Recall Campaign Bulletin

Campaign No. 2023070012, May 2024

Revision D: 5/31/2024

Replace Fuel Pump Delivery Module – Wave 6

Figure 2

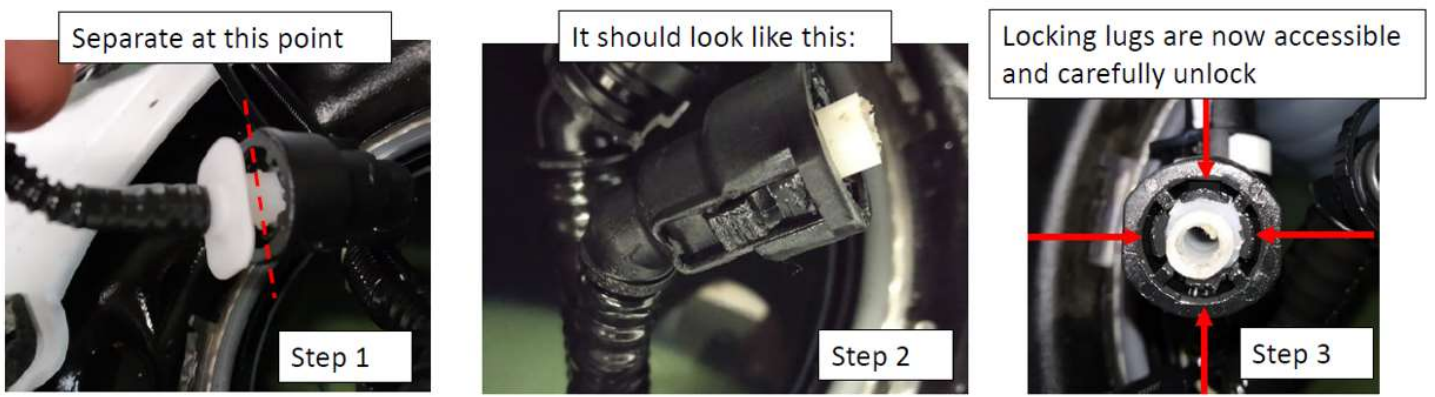
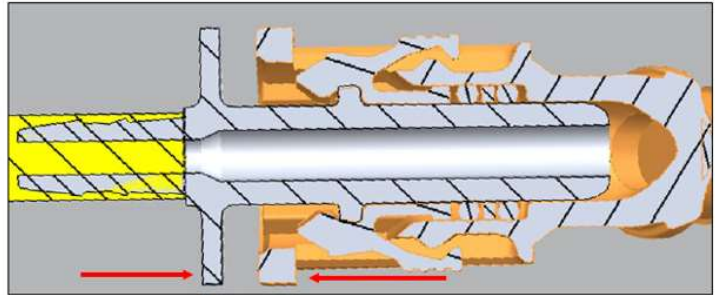
i Only model 206, 232: Note on disassembly of suction jet pump drive line quick connector. The procedure step 1-3 should only be performed when the quick disconnect is not working (**Figure 2**).

MRA2 Quick Connector suction jet pump drive line

Squeeze the QC connection by at least 1mm, then unlock the latching lugs. If this is not possible. Step 1 -3

Figure 3 (release corresponding connector and disconnect the contacts)

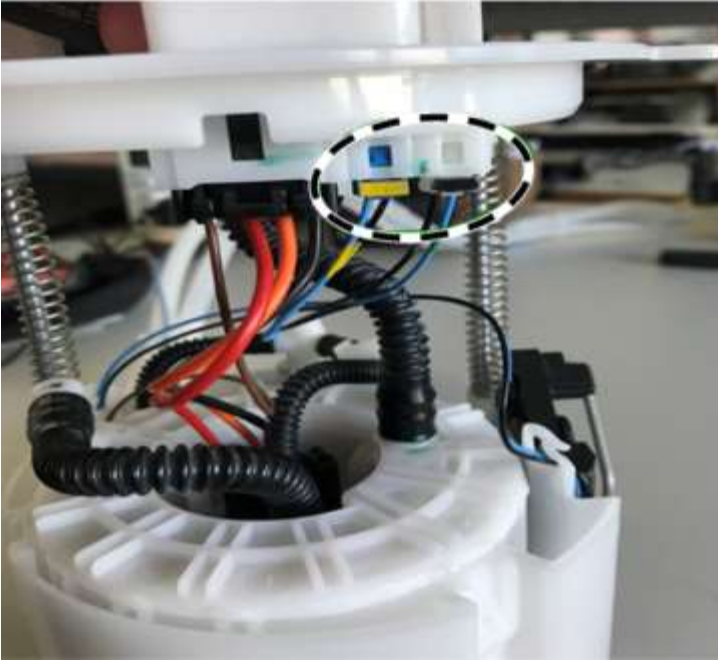
i Delivery modules that are delivered **without float-and-lever sensor** must be modified. (Figures 3-5)

Figure 4 (remove lines from routing clip)

Figure 5 (using a screwdriver, carefully push float-and-lever sensor housing away from module housing and at the same time push float-and-lever sensor housing upwards.)
